FINAL PRE-APPLICATION CONFERENCE REPORT
Manning Meadows Subdivision (2025-003-PAC)

Meeting conducted on Wednesday, February 12, 2025 at 2:00 p.m.

Site Address	1819 NE 339 th Street (Parcel No. 209048000)
Legal Description	#16, #53 & #76 SEC 2 T4N R1E
Applicant	Ian McGrady-Beach LGI Homes (360) 998-6814 ian.mcgrady-beach@lgihomes.com 709 Washington Street Suite 200 Vancouver, WA 98660
Applicant's Representative	Travis Johnson PLS Engineering (360) 944-6519 pm@plsengineering.com 604 W Evergreen BLVD Vancouver, WA 98660
Property Owner	Kenneth & Debra Manning 1819 NE 339 th St., La Center, WA 98629
Proposal	Rezone the project site from LDR-7.5 to MDR-16 and subdivide 11.55 acres into 84 single-family attached and detached residential lots. The site is currently located in the LDR 7.5 zone district.
Date of Conference	February 12, 2025

Manning Meadows Subdivision

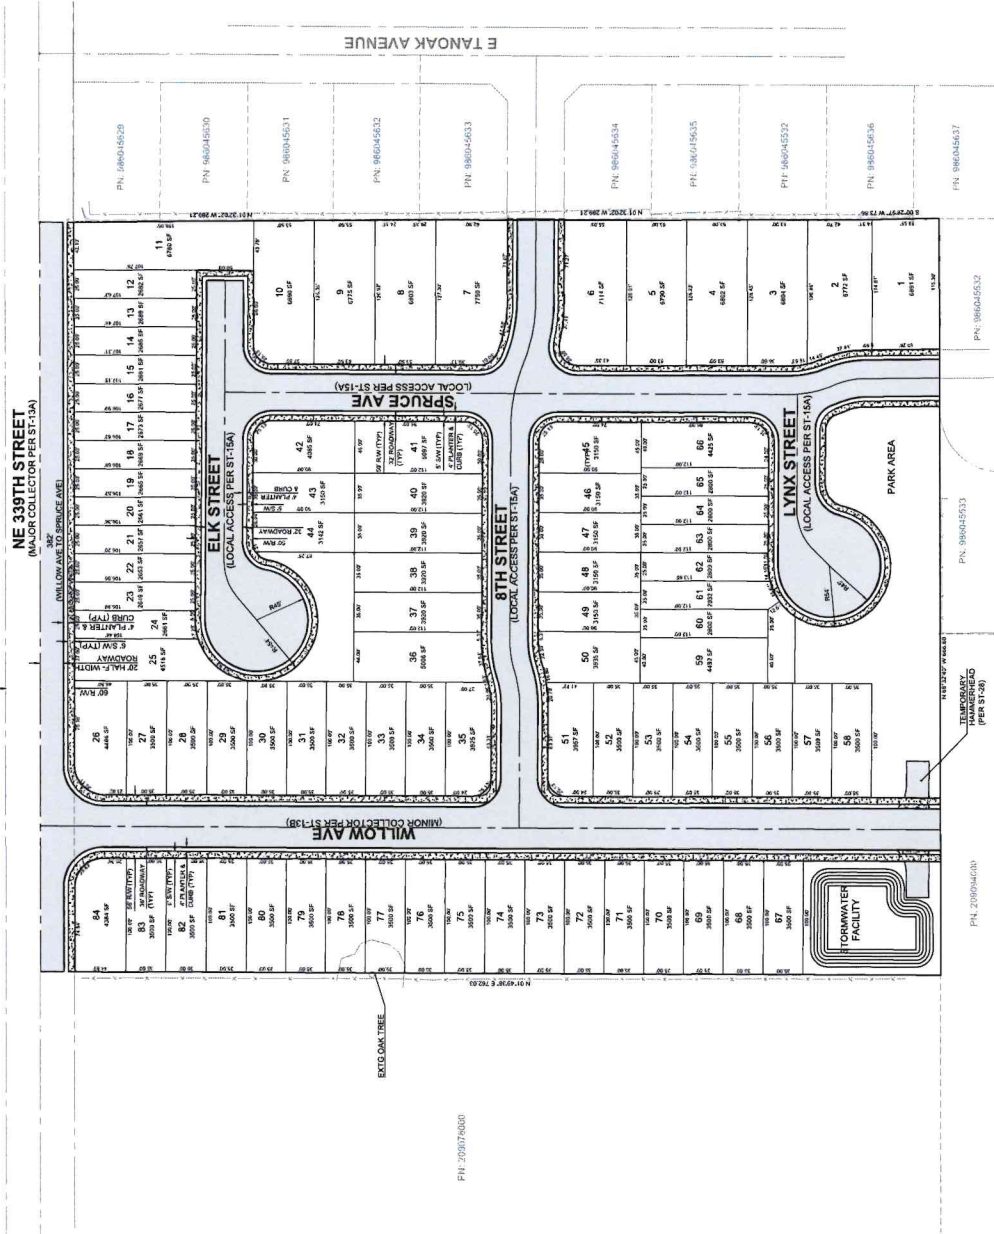
Willow Ave current alternative hammerhead shall meet the criteria of the code. Appendix D 70' long and 20' wide with a 28' radius turn.
